OCONEE NUCLEAR STATION, UNIT NO. 1

AMENDMENT TO FACILITY OPERATING LICENSE

Amendment No. 71
License No. DPR-38

SAFETY EVALUATION BY THE OFFICE OF NUCLEAR REACTOR REGULATION
SUPPORTING AMENDMENT NO. 71 TO FACILITY OPERATING LICENSE NO. DPR-38

Figure 3.1.2-1A

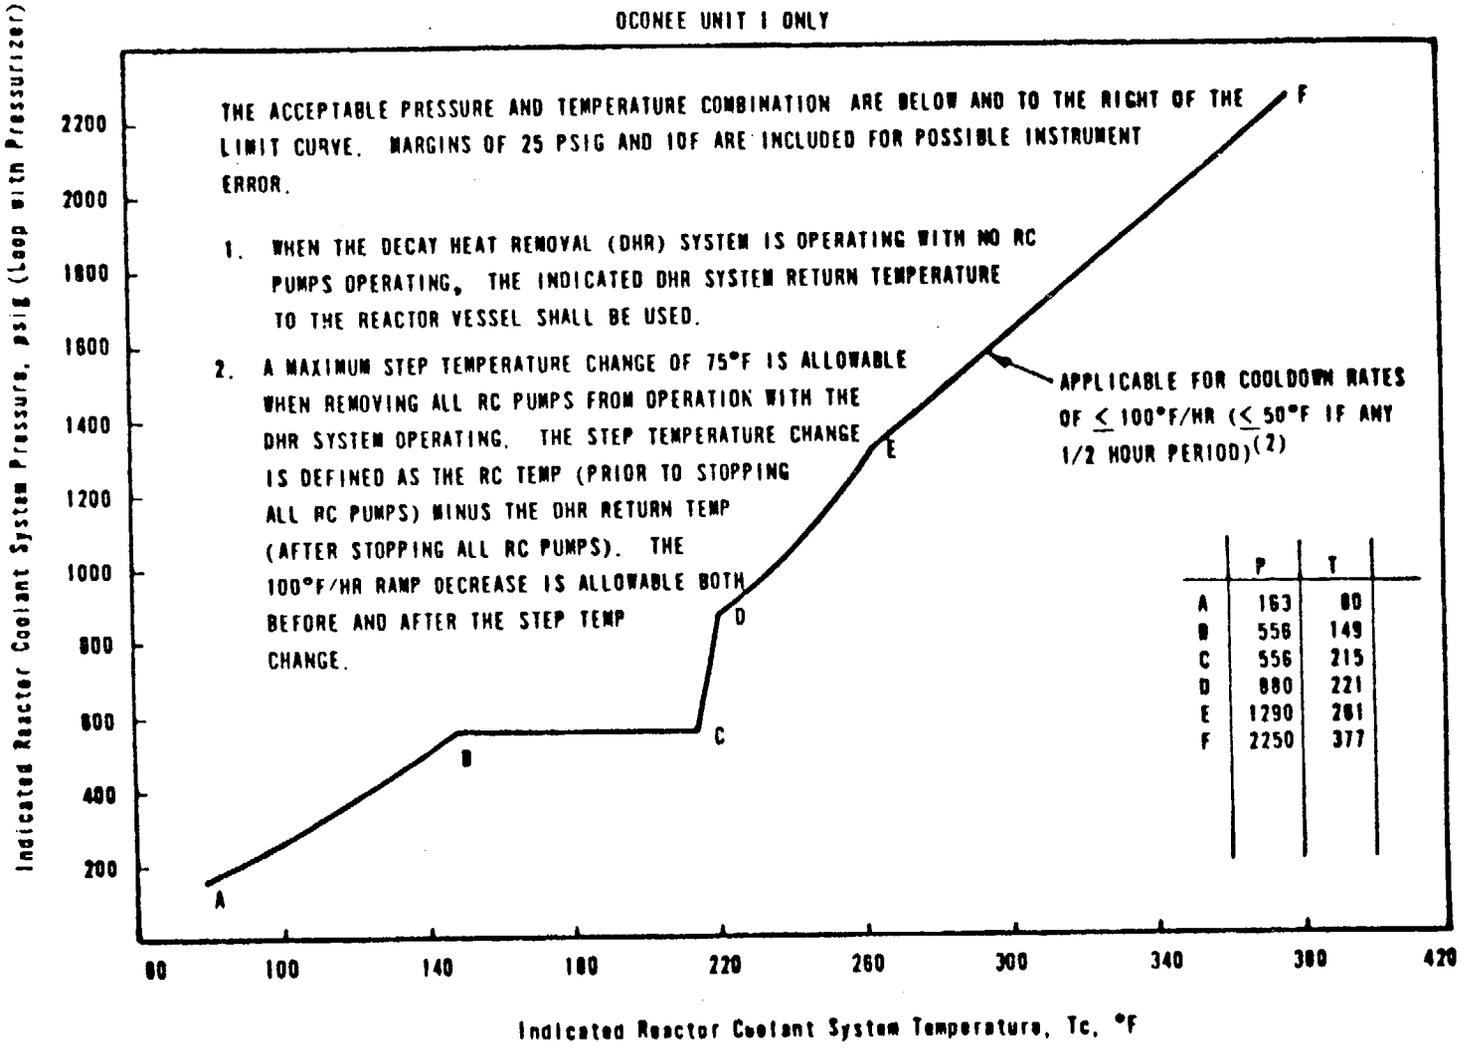
Heatup rates and allowable combinations of pressure and temperatures shall be limited in accordance with Figure 3.1.2-1A Unit 1
3.1.2-1B Unit 2
3.1.2-1C Unit 3

REACTOR COOLANT SYSTEM
 NORMAL OPERATION-HEATUP LIMITATIONS APPLICABLE FOR FIRST
 6.0 EFFECTIVE FULL POWER
 YEARS

We conclude that the proposed pressure-temperature operating limits and changes to Technical Specification 3.1.2 are acceptable but only through 6 EFPY instead of 8 EFPY as proposed by DPC. DPC has agreed to this change. For this operating period the proposed pressure-temperature operating limits are in accordance with the fracture toughness requirements of Appendix G, 10 CFR Part 50. Compliance with Appendix G in establishing safe operating limitations will ensure adequate safety margins during operation, testing, maintenance and postulated accident conditions and constitute an acceptable basis for satisfying the requirements of NRC General Design Criterion 31, Appendix A, 10 CFR Part 50.

Figure 3.1.2-2A

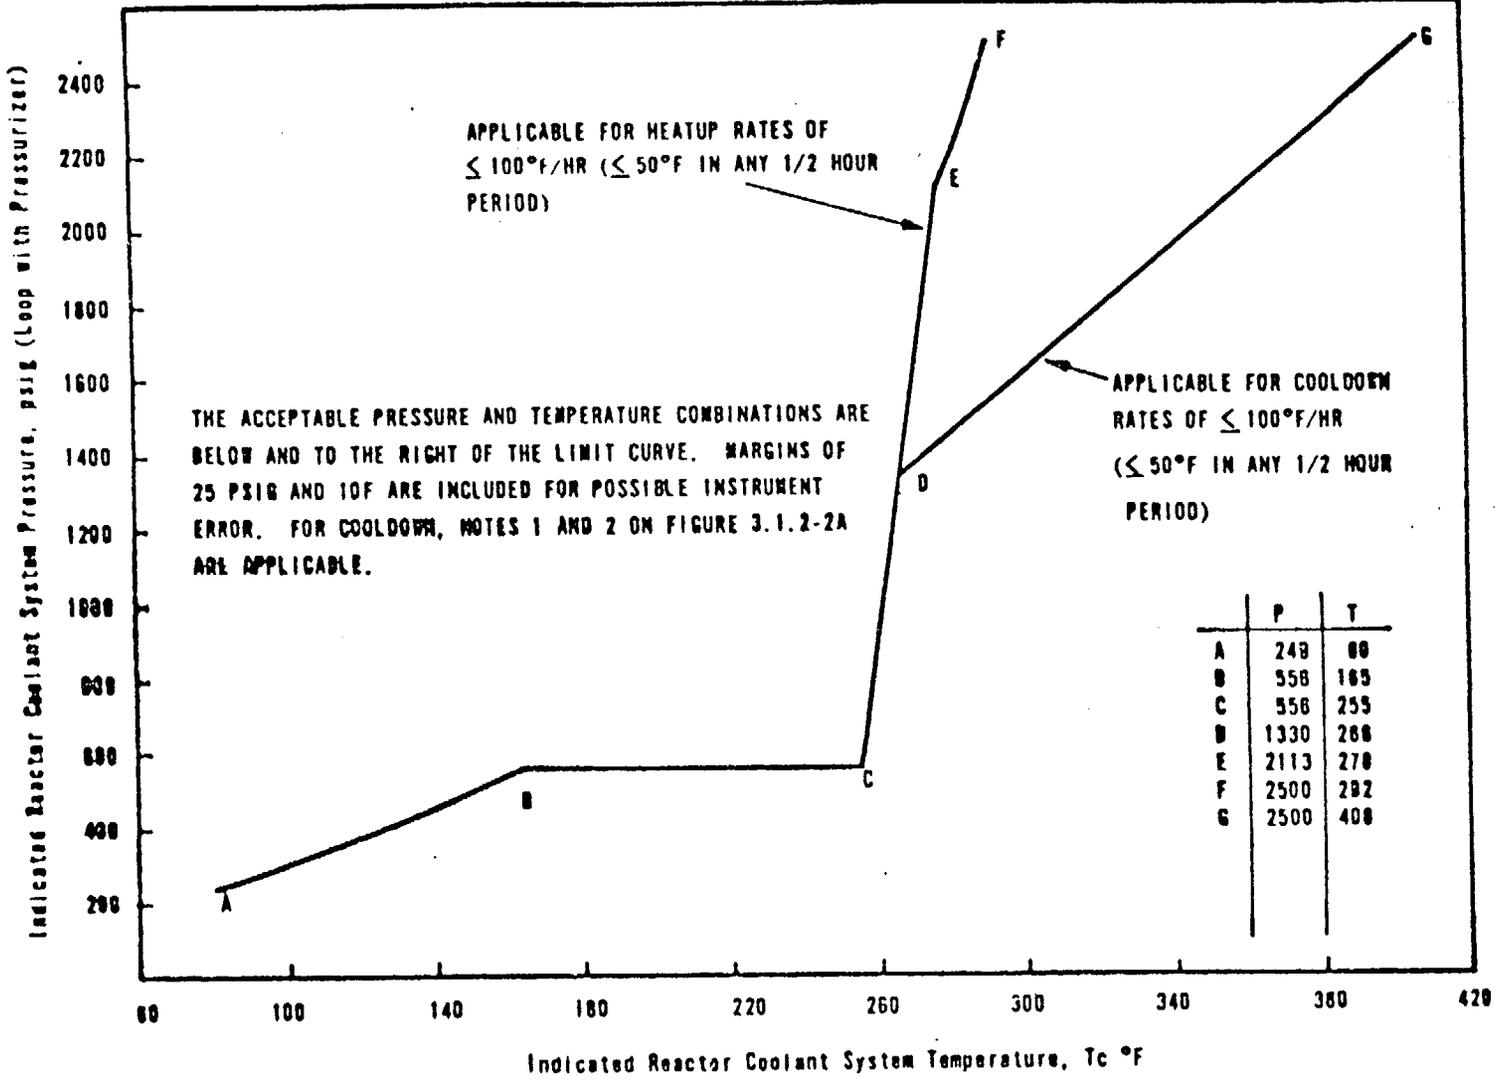
Cooldown rates and allowable combinations of pressure and temperature shall be limited in accordance with Figure 3.1.2-2A Unit 1
3.1.2-2B Unit 2
3.1.2-2C Unit 3

REACTOR COOLANT SYSTEM
 NORMAL OPERATION-COOLDOWN
 LIMITATIONS APPLICABLE FOR
 FIRST 6.0 EFFECTIVE FULL
 POWER YEARS UNIT 1
 OCONEE NUCLEAR STATION
